ENGINE DISTRIBUTORS SERVICE BULLETIN

GX120 • GX160 • GX200 FUEL FILLER CAP DOES NOT VENT PROPERLY

FUEL FILLER CAP

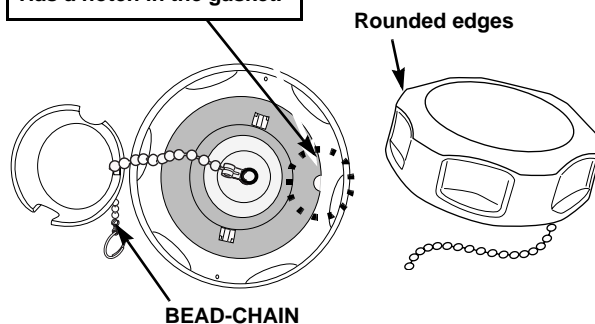
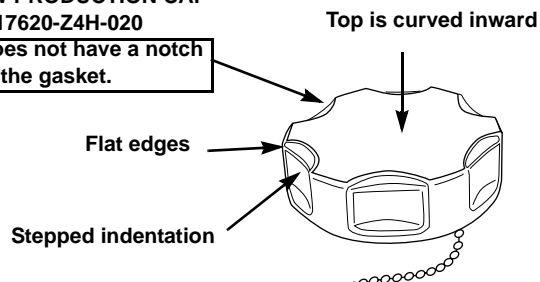
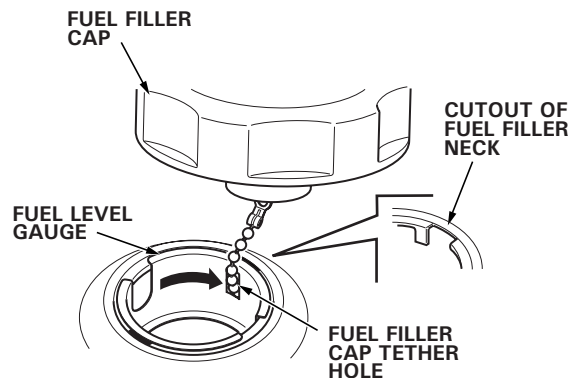
Replace the fuel filler cap with either one of the new style vented caps shown.

- The countermeasure cap can be recognized from the original cap by a notch in the gasket.
- The new production cap can be identified by flat edges, stepped indentations, and a top that is curved inward.

COUNTERMEASURE CAP
PN 17620-Z4H-010

Has a notch in the gasket.

NEW PRODUCTION CAP
PN 17620-Z4H-020

Does not have a notch in the gasket.

The countermeasure cap and new production cap are interchangeable with each other.
